**PLANNED UNIT DEVELOPMENT
& SUBDIVISION STAFF REPORT****Date: July 11, 2013****SUBDIVISION NAME**

Northside LTD/Joint Venture Subdivision, Resubdivision of and Addition to Lot 3A

Planned Unit Development Approval to allow shared access between two lots and Subdivision approval to create a legal lot of record from two metes and bounds parcels.

SITE PLAN

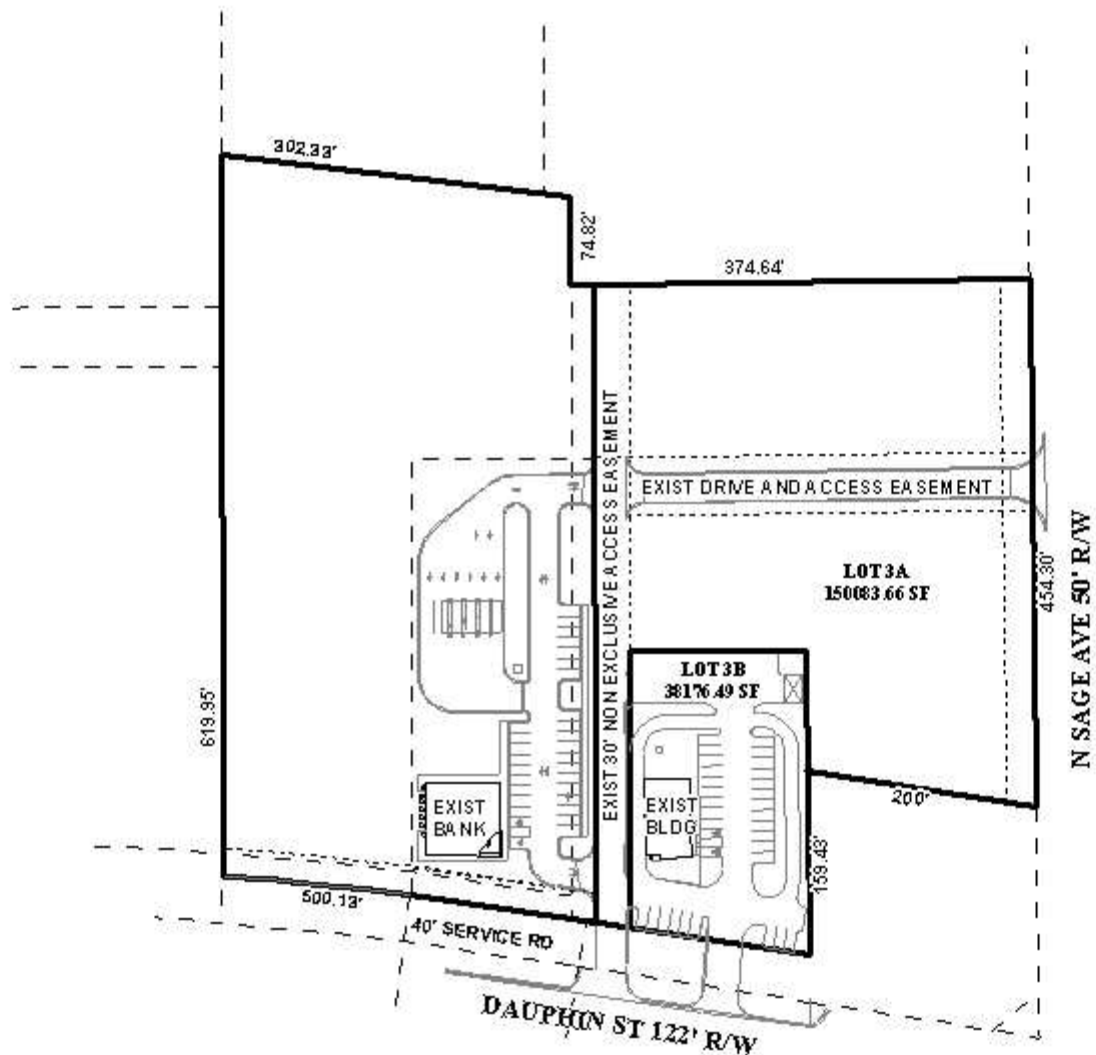
4. Label the property corner (set or found) at the SE corner of Lot 3B.
5. Correct the distance labels shown on the eastern property line of Lot 3B.

6. Remove the existing improvements shown that are not needed for the Subdivision Plat. Some of the information shown as existing on adjacent Lots 1A and 2A do not exist, and the new Regions Bank is not shown. Also, the access drive from Sage Avenue (Lot 3A) is not shown.

The site plan illustrates the dumpster on the new building site, but does not illustrate the provision of a dumpster buffering (and the connection to sanitary sewer) and compliance with the setback requirements of 0 or 5-feet; therefore, it should be noted that ALL

- 2) depiction and labeling of the 25--foot minimum building setback line on the Final Plat;
- 3) labeling of the lot size in square feet on the Final Plat;

- 1) revision of the site plan to depiction of a 25-feet minimum building setback,;
- 2) compliance with Engineering comments: *(1. Add a note to the PUD drawing that states: Any work performed in the existing ROW (right-of-way) such as driveways, sidewalks, utility connections, grading, drainage, irrigation, or landscaping will require a ROW permit from the City of Mobile Engineering Department (208-6070) and must comply with the City of Mobile Right-of-Way Construction and Administration Ordinance (Mobile City Code, Chapter 57, Article VIII). 2. Add a note to the PUD drawing that states: Any and all proposed development will need to be in conformance with the Storm Water Management and Flood Control Ordinance (Mobile City Code, Chapter 17, Ordinance #65-007 & #65-045); the City of Mobile, Alabama Flood Plain Management Plan (1984); and, the Rules For Erosion and Sedimentation Control and Storm Water Runoff Control. The existing detention facility will need to have its volume capacity and functionality verified by a licensed PE. 3. A complete set of construction plans for the site work – including, but not limited to, drainage, utilities, grading, storm water detention systems, paving, and all above ground structures, will be required to be submitted with the Land Disturbance permit. These plans are to be submitted and approved prior to beginning any of the construction work. 4. Must comply with the following Engineering Department Policy Letters: 1) 5-13-2009 Policy Letter (Car wash drains and dumpster pads to drain to Sanitary Sewer system), and 2) 8-4-2004 Policy Letter (video inspection of new Storm Sewer System Piping.);*

- 3) revision of the site plan to depict lighting of the parking area compliance with Sections 64-4.A.8. of the Zoning Ordinance;
- 4) labeling of the lot size in square feet on the site plan;
